<b>HYUNDAI</b> <b>Technical Service Bulletin</b>	GROUP <b>RECALL</b>	NUMBER <b>18-01-007-1</b>
	DATE	MODEL(S)
	<b>JUNE, 2018</b>	<b>2013-2014MY SONATA (YF) SANTA FE SPORT (AN)</b>
<b>SUBJECT: SONATA / SANTA FE SPORT GDI ENGINE INSPECTION / REPLACEMENT (RECALL CAMPAIGN 162)</b>

**This TSB supersedes TSB# 18-01-007 and modifies the Parts Information and Warranty Information sections.**

**Exhaust Stud Position Relocation Information**

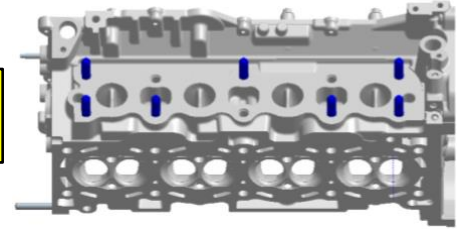
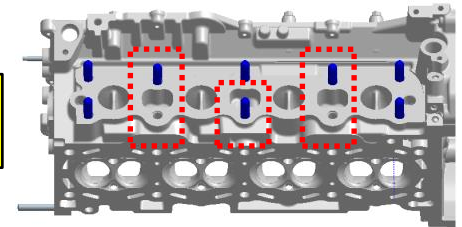
4. **For 2.4L with ULEV / FED emissions only**  
All 2.4L engines with part numbers in the Parts Information section are produced with the exhaust manifold studs configured for SULEV / CAL emissions package.

2.4L vehicles with a ULEV / FED emissions package require 2 exhaust studs to be relocated on the new engine and 1 exhaust stud transferred over from the old engine.

- Use a commercially available stud removal tool or use the double-nut technique to complete this step.
